Subject: DRAFT Response to U.S. EPR Design Certification Application RAI No. 413, FSAR Ch. 7, 9 Questions
Sent Date: 12/13/2010 10:24:57 AM
Received Date: 12/13/2010 10:25:07 AM
From: BRYAN Martin (EXTERNAL AREVA)

Request for Additional Information No. 413(4772), Revision 1, Supplement 2

U. S. EPR Standard Design Certification

SRP Section: 07.08 - Diverse Instrumentation and Control Systems

Figure 07.08-22-1 — D3 Increase in Steam Flow – Plot of Normalized Minimum DNBR and Maximum LPD to SAFDL

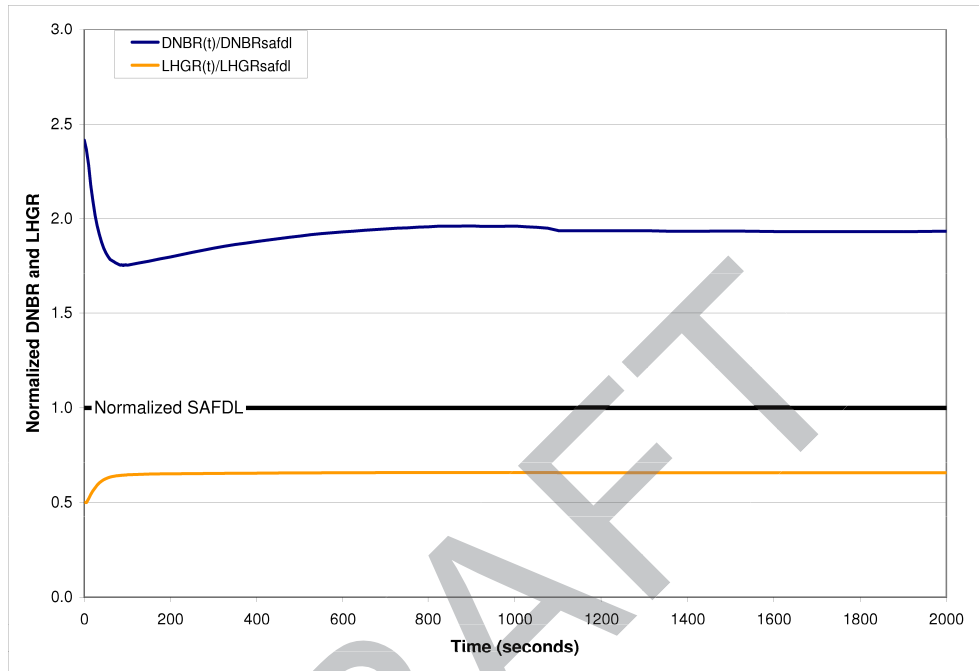
Provide a plot of DNBR normalized to SAFDL for the D3 analysis of the Increase in Steam Flow event, along with an explanation of the basis for the initial DNBR margin. In addition, address margin to the LPD SAFDL for the D3 analysis of the Increase in Steam Flow event.

Section A.3.2.3 of Appendix A to ANP-10304 Rev 1 states that no fuel failure is predicted for the Increase in Steam Flow event. In comparing the D3 analysis of ANP-10304 Rev 1 to the corresponding FSAR Tier 2, Chapter 15 analysis, the maximum predicted power level is substantially higher in the D3 analysis (130% versus approximately 108%). Although initial DNBR margin is expected to be higher given the best-estimate assumptions of the D3 analysis, the decrease in DNBR due to the much higher power transient condition could be more than offsetting.

A plot of departure from nucleate boiling ratio (DNBR) and linear power density (LPD) normalized to the specified acceptable fuel design limit (SAFDL) for the beginning of cycle (BOC) increase in steam flow event is included in Figure 07.08-22-1—D3 Increase in Steam Flow – Plot of Normalized Minimum DNBR and Maximum LPD to SAFDL below.

Figure 07.08-23-1

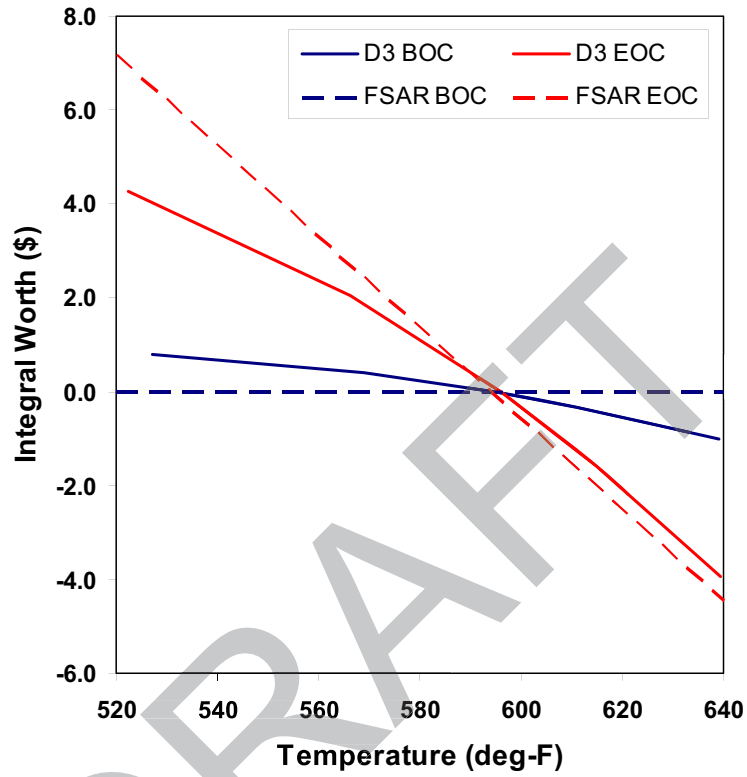
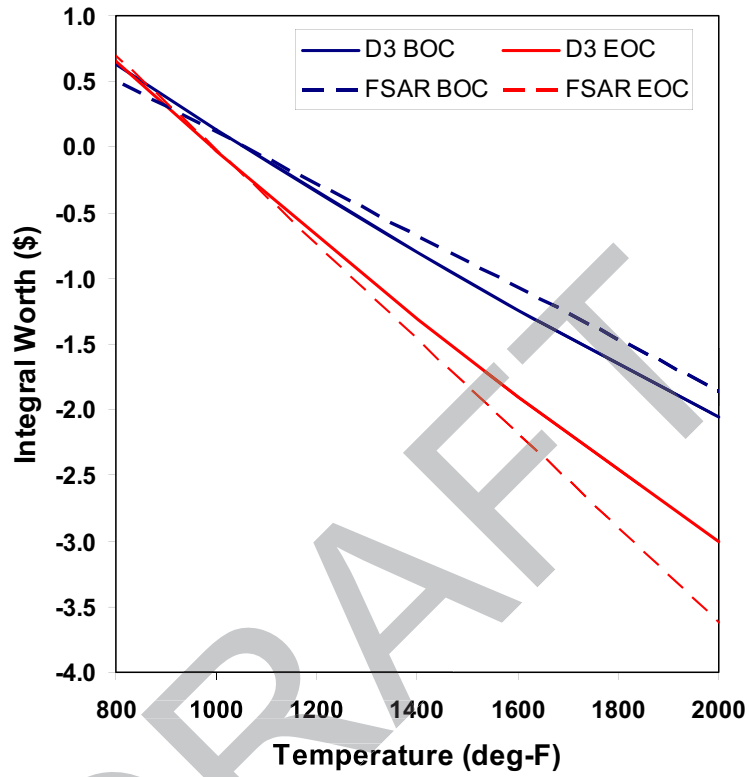
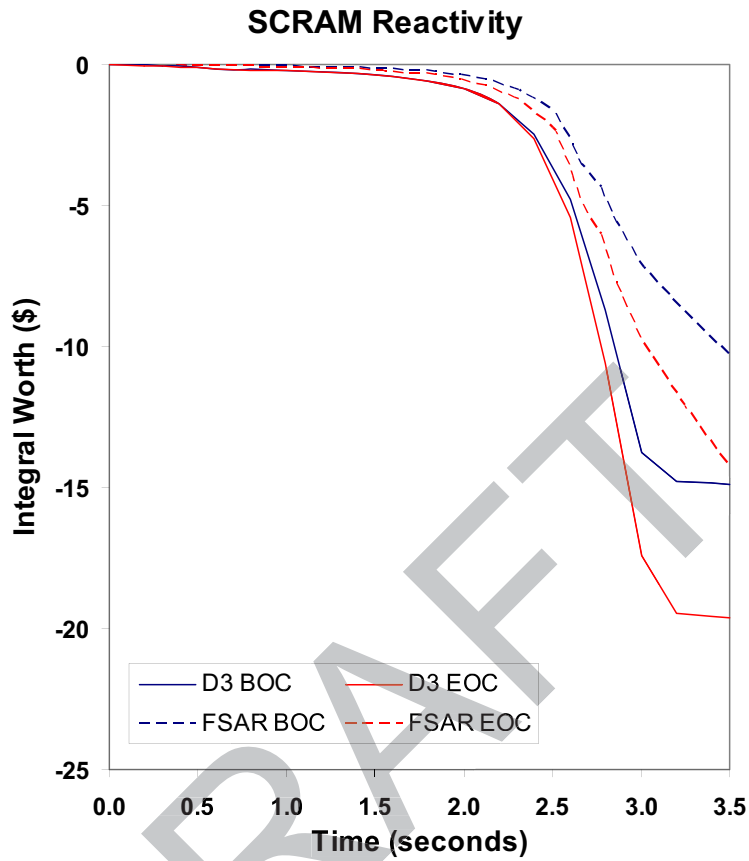
For the D3 analysis provided in “U.S. EPR Diversity and Defense-in-Depth Assessment Technical Report” (D3-TR), ANP-10304, Revision 1 (ML093420199), Appendix A, the following additional information is needed for the MSLB case with PS SWCCF at full power conditions:

a) Demonstrate that a return to criticality does not occur following reactor trip,

The FSAR Tier 2, Chapter 15 analysis identifies the main steam line break (MSLB) initiated from HZP as the limiting Steam System Piping Failure event, resulting in a small number of fuel failures due to the SAFDL on cladding strain (Local Power Density) being exceeded. [NOTE: HZP is typically more limiting than HFP because the absence of decay heat will allow greater cooldown of the RCS and therefore an increase in moderator temperature reactivity.] Therefore, additional information is needed for the case with PS SWCCF at full power conditions for the staff to complete its review.

The difference between this analysis and that documented in the U.S. EPR FSAR Tier 2, Chapter 15 involves the use of best estimate moderator temperature coefficient (MTC), Doppler fuel temperature coefficient (DTC), and scram reactivity. The difference in these parameters between the best estimate and FSAR Tier 2, Chapter 15 values are given in Table 07.08-23-2 and Figures 07.08-23-1 through 07.08-23-3.

The U.S. EPR FSAR Tier 2, Chapter 15 values include biases and account for calculational uncertainties. The best estimate values are determined from the core analysis models for projected Cycle 1 and the equilibrium cycle. The scram reactivity use in the D3 analysis does not assume a stuck rod.

Figure 07.08-33-1—Comparison of PCT: RCP NO Trip (New) vs. RCP TRIP (Original)

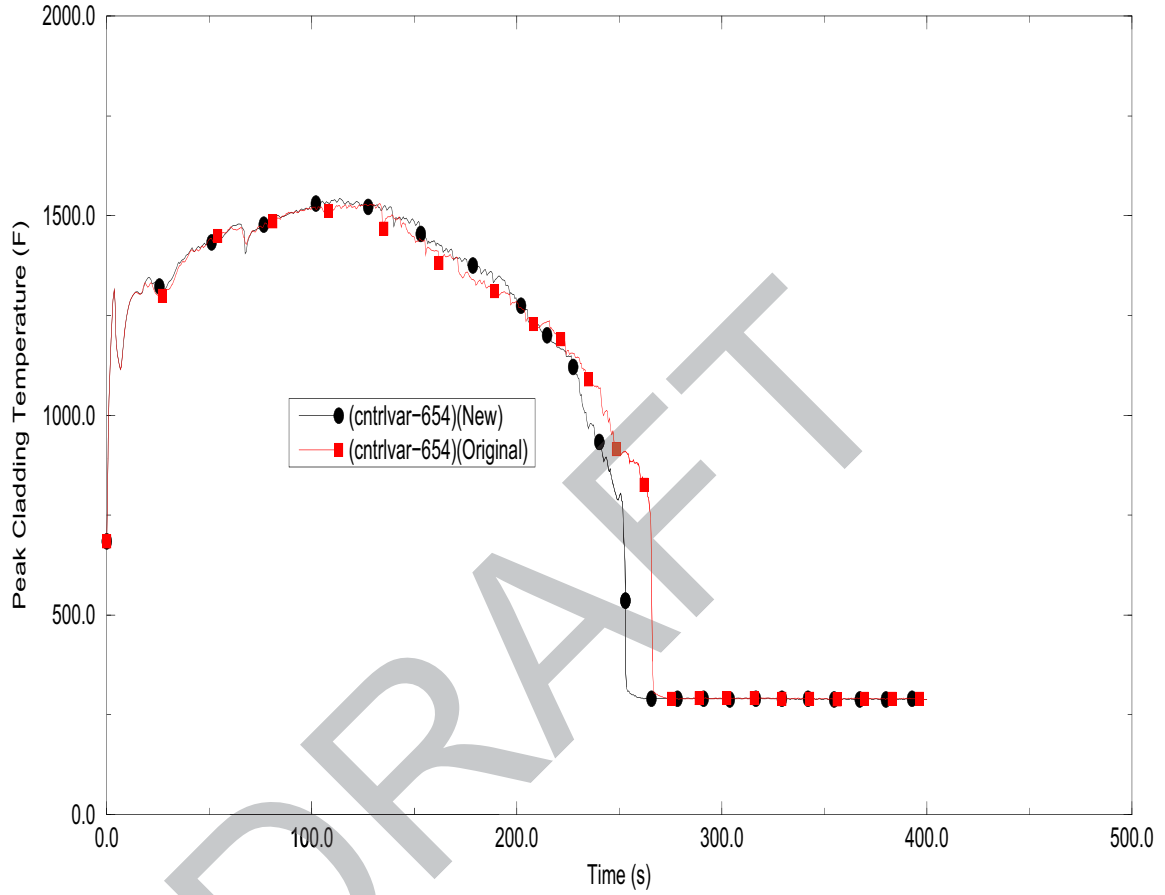
- a) A summary of the sensitivity calculation results referred to in Section A.3.7.3.1 that demonstrate the conclusion that continued operation of RCPs does not significantly affect the LBLOCA results, and
- b) An assessment of the effects of continued operation of the RCPs during two phase and vapor LBLOCA conditions on the RCPs themselves, i.e., cavitation or overspeed damage resulting in subsequent unavailability of the RCPs.

Figure 07.08-33-1 is a comparison of PCT between new and original cases and shows that the deactivation of the automatic RCP trip has a minor impact (<30 °F) on the PCT calculation.

Results for Larger SBLOCA Breaks: 6.0 inch DIAMETER Break
Figure 07.08-34-1—SBLOCA 6.5 inch diameter Break: Loop Seal Clearing Time

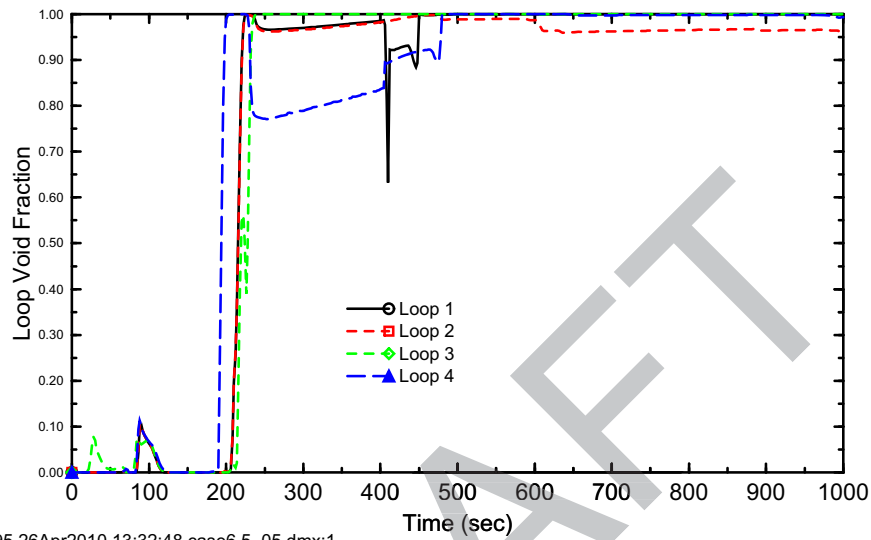
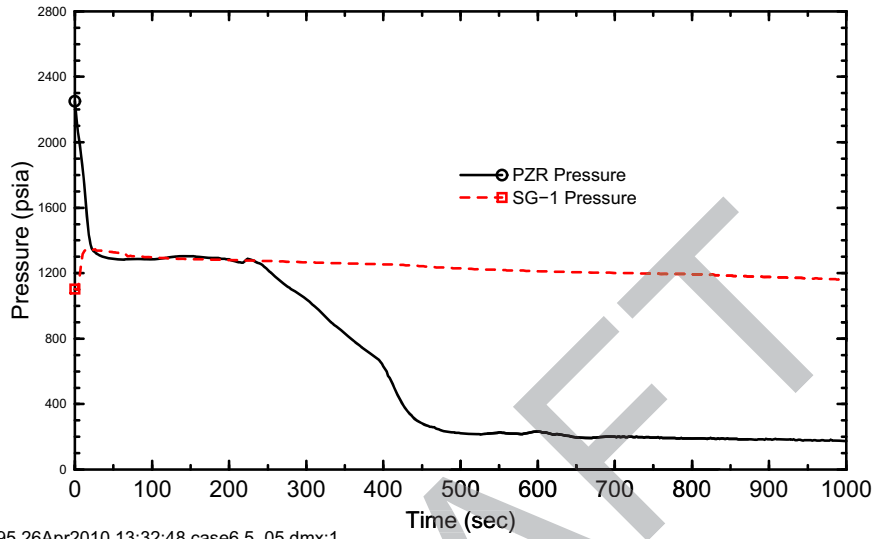
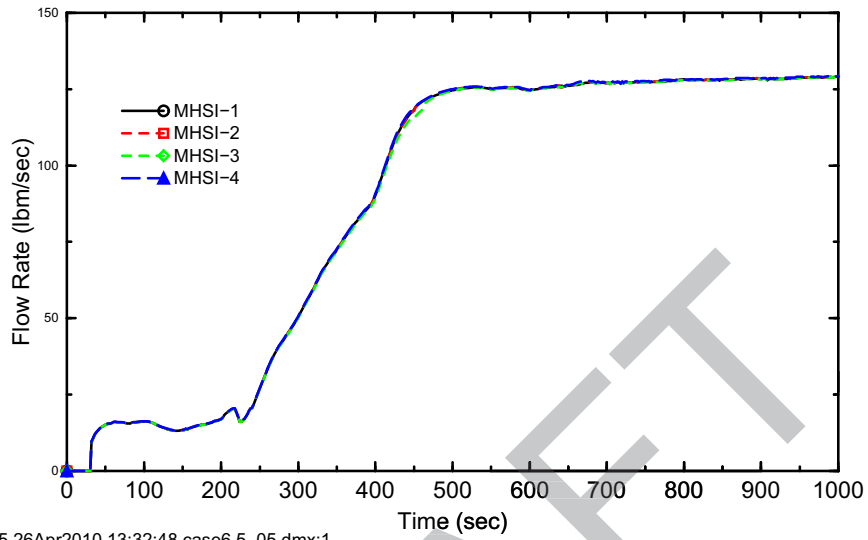
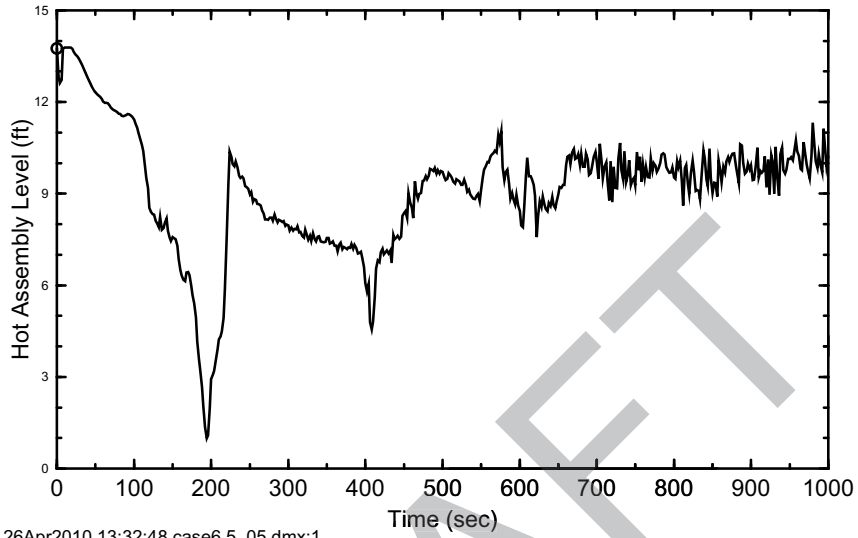
Provide a resolution of whether the turbine bypass system may be relied upon for partial cooldown during a SBLOCA with SWCCF in the PS. If manual operator actions are required to be performed, provide the timing requirements and a description of the operator actions, including whether such operator actions are covered by existing plant operating procedures or symptom-based EPGs.

ANP-10304 Rev 1 Section A.3.7.3.2 describes a condition where the MSRT partial cooldown function is unavailable during a SBLOCA with SWCCF in the PS and the turbine bypass system provides the partial cooldown function, as long as the MSIVs remain open. The applicant notes that an on-going review could affect the use of the turbine bypass system during SBLOCA. The staff is not able to identify design descriptions that would permit sufficient understanding in order to complete the safety evaluation.

SBLOCA breaks at the upper end of the spectrum rely less on the steam generators (SGs) to remove primary energy. Figure 07.08-34-1 shows that decay heat is removed through the break; the loop seals clear early in the transient, opening the path for the RCS depressurization. Figure 07.08-34-2 shows that the RCS depressurizes to the MHSI actuation signal independent of the SG ability to remove heat. Figures 07.08-34-3 and 07.08-34-4 show how as the RCS

depressurizes further, the MHSI flow overcomes the break flow and replenishes the core . Subsequent injection from the LHSI and accumulators assures extended core cooling.

For this break category, the highest calculated peak cladding temperature (PCT) is 1152°F for the 9.7-inch diameter break with reactor coolant pumps (RCPs) tripped at 60 seconds.
